ADDENDUM NO: 1

PROJECT: **SITE IMPROVEMENTS AT FRANKLIN CENTRAL JUNIOR HIGH**

CONTEXT PROJECT NO: 22-1613 DATE: 2/13/2024 BY: Fred Prazeau

Sheet No:
L100

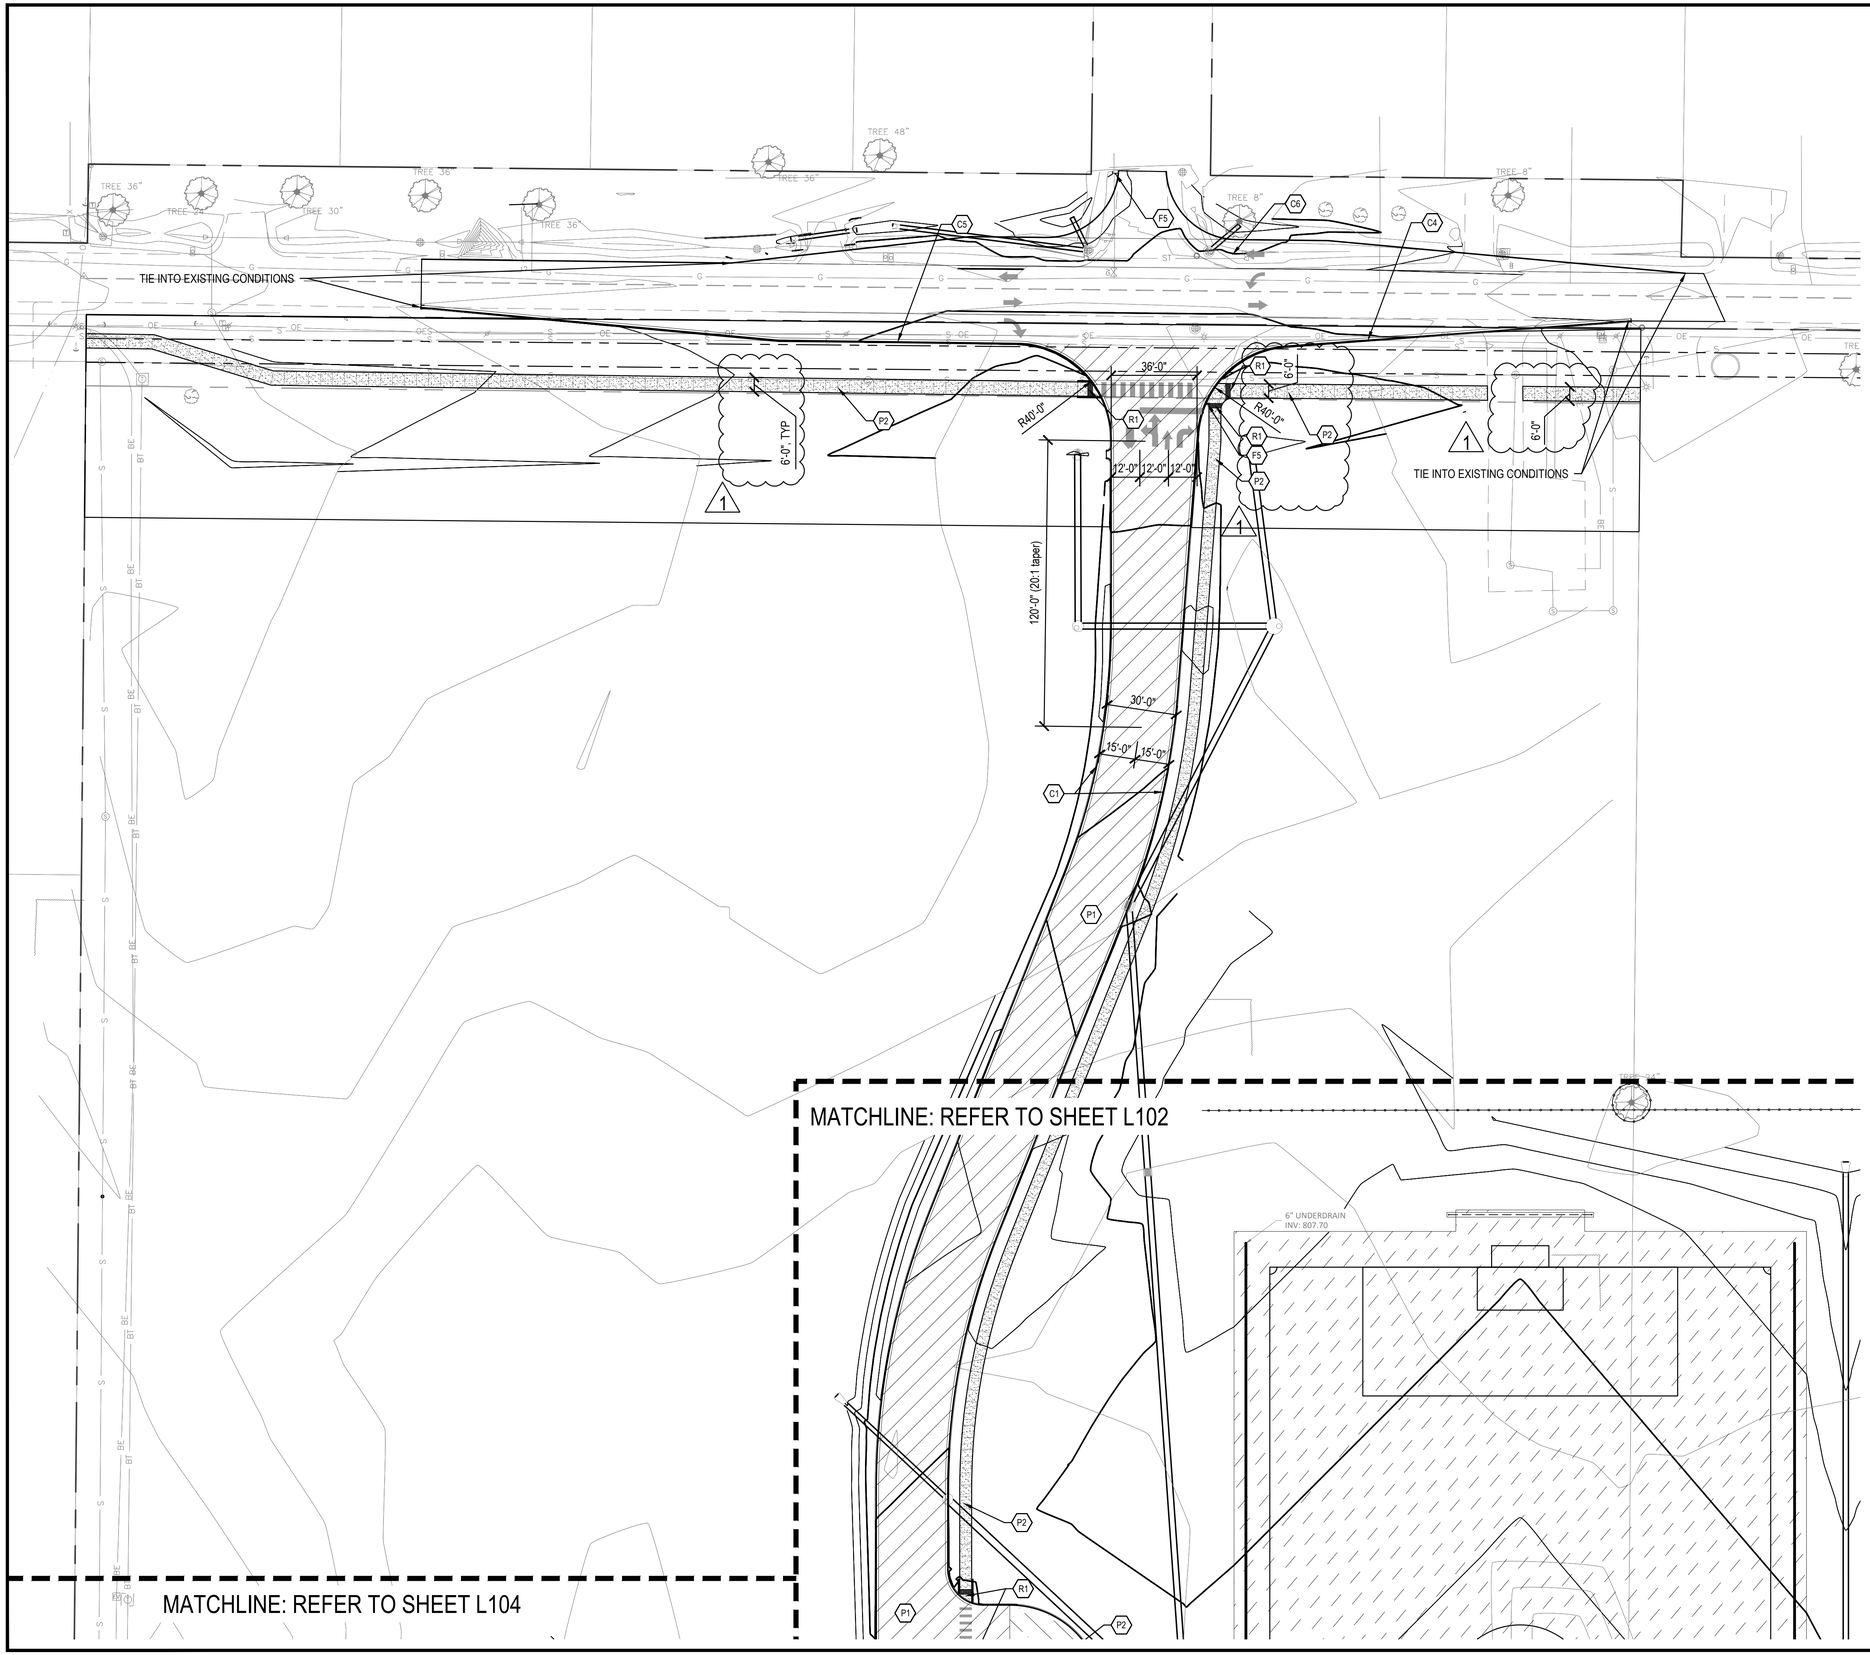
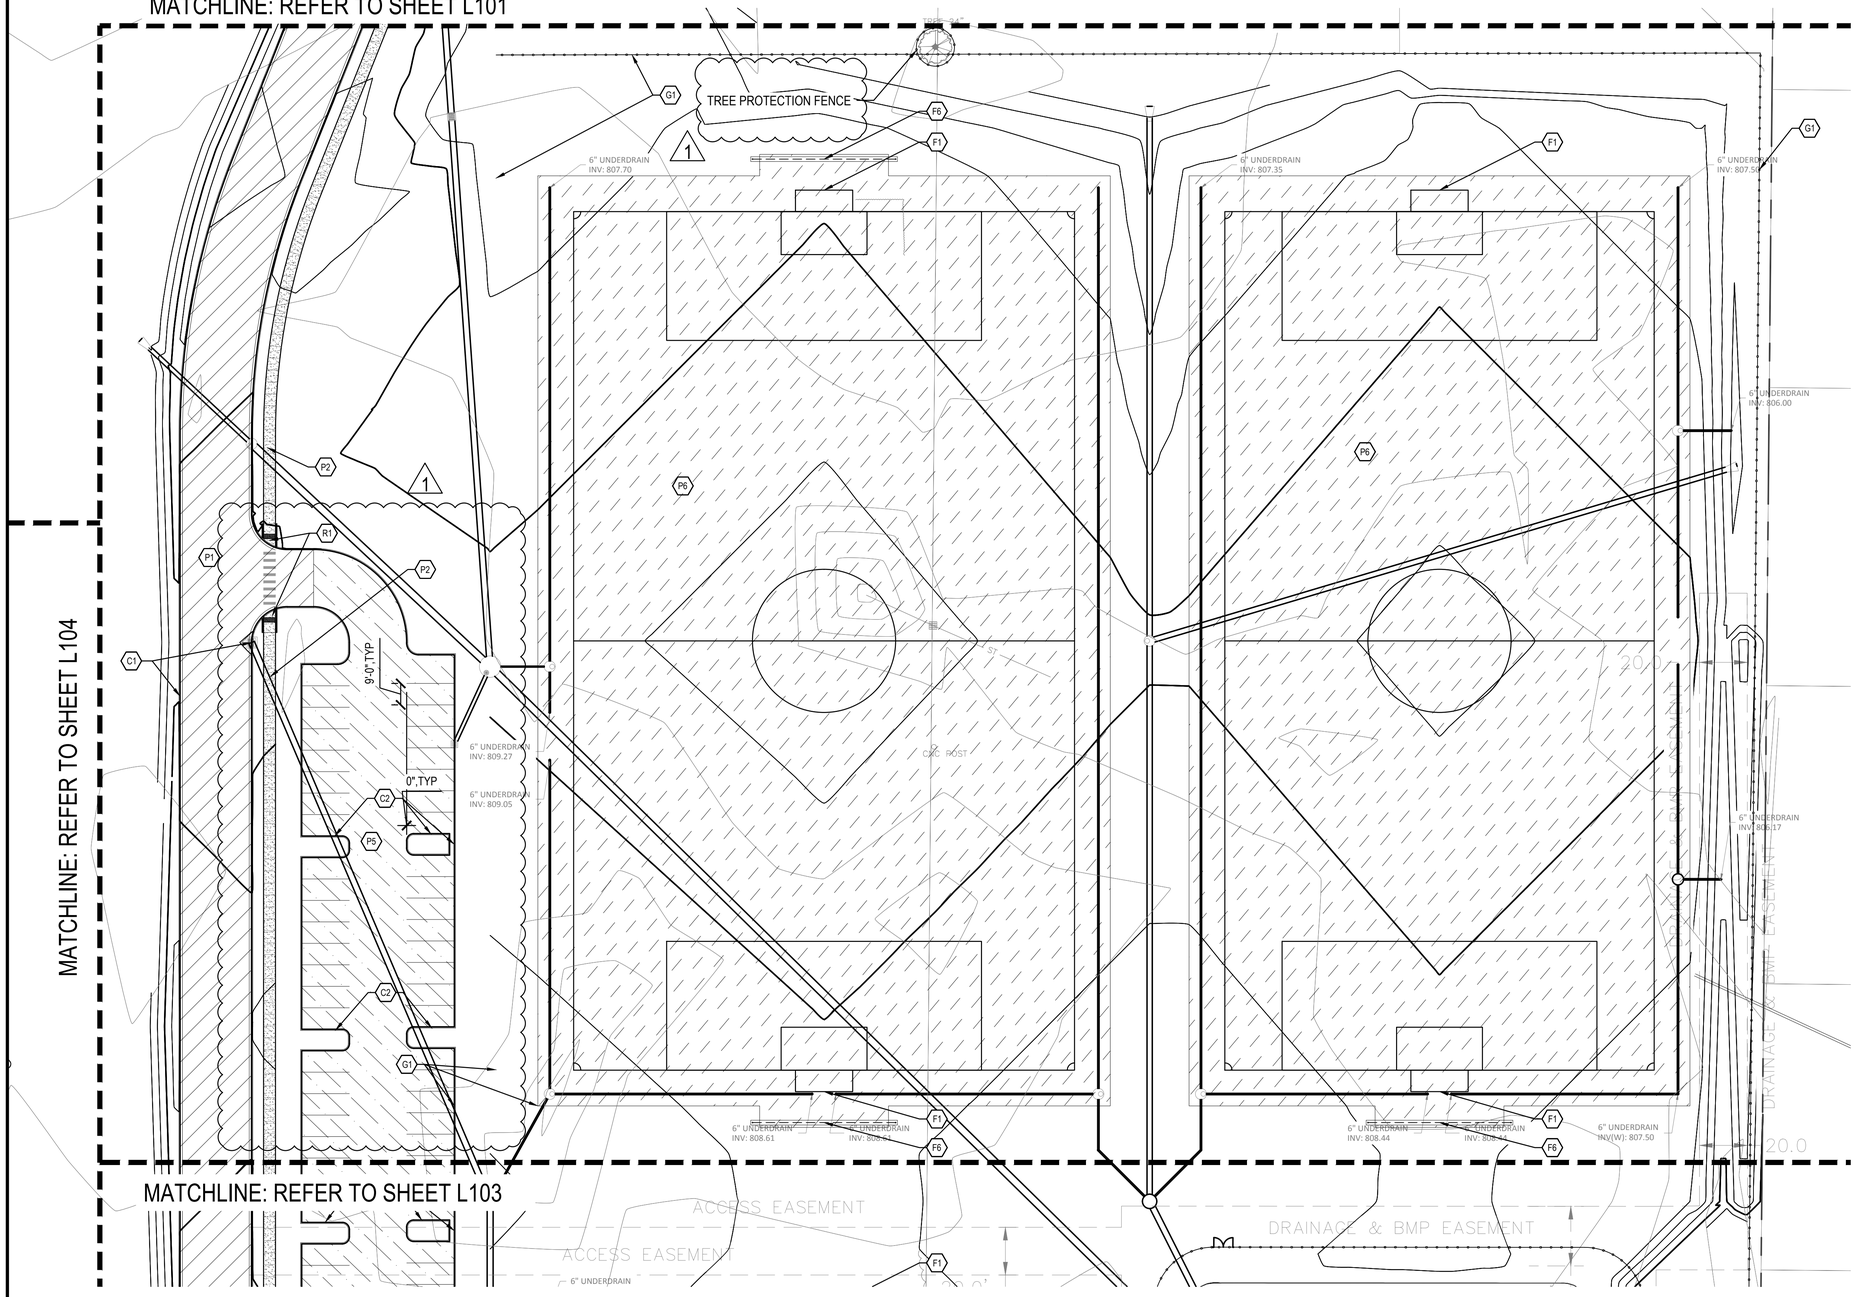
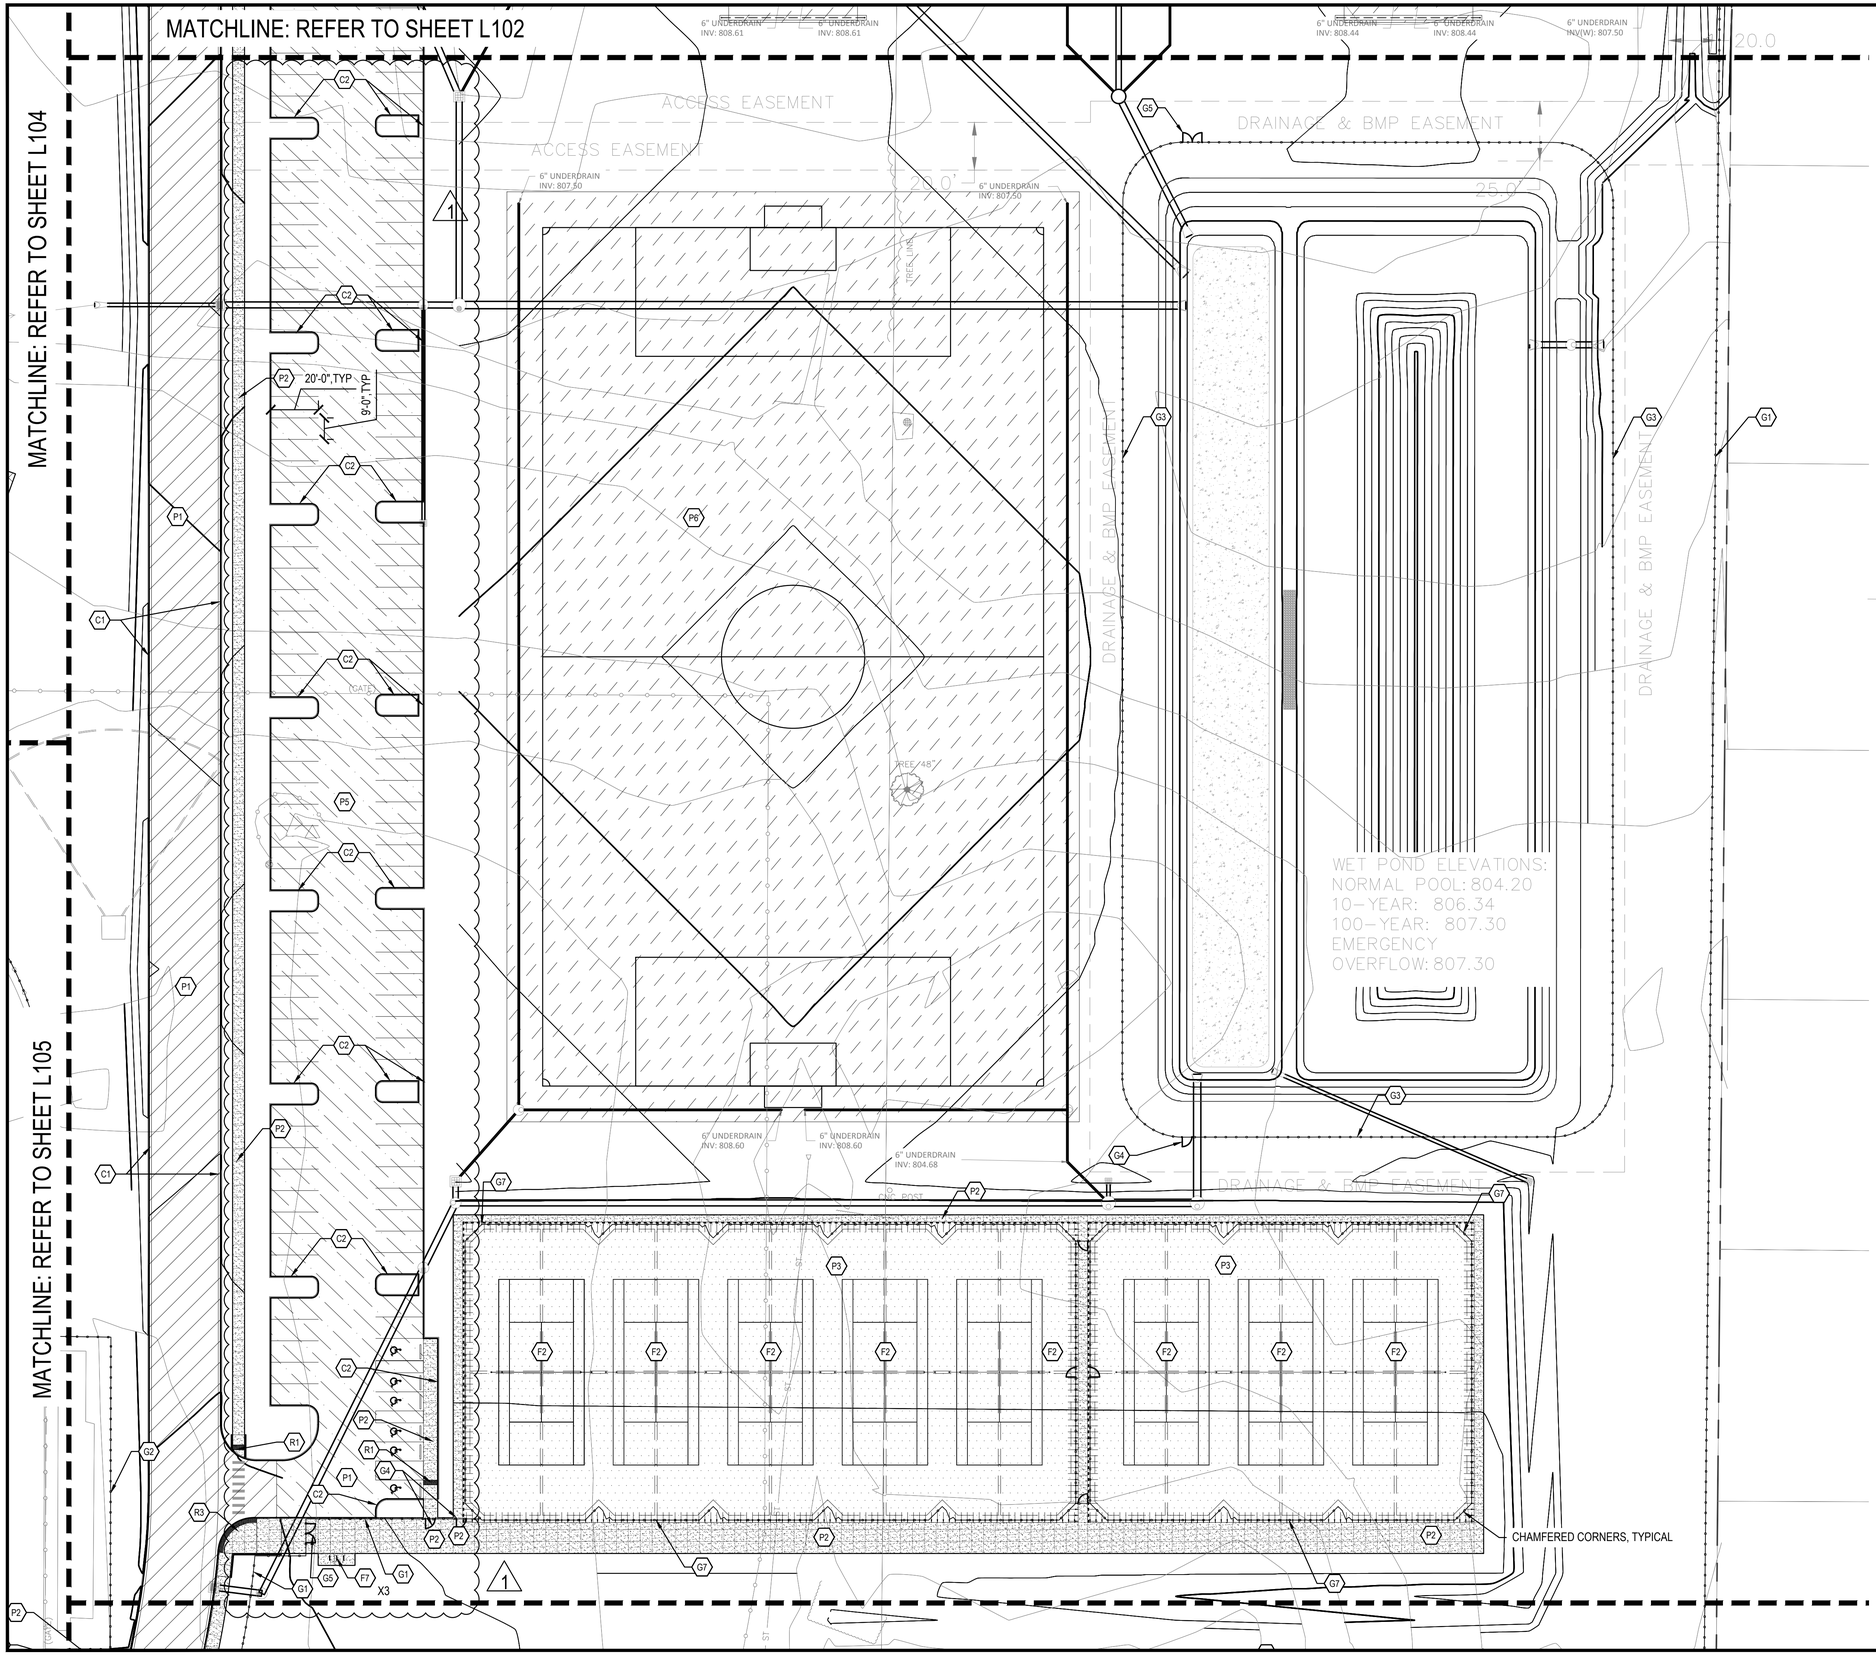
1. L100-Series Material Identification Plans reissued to address City comments, including clarifications to curb ramps, crosswalks, tree protection (single tree), soccer parking islands, and bike racks.
2. L300-Series Landscape Plans reissued to address City comments, including additional landscape planting, parking lot islands, and tree protection (single tree). Sheet L310 added.
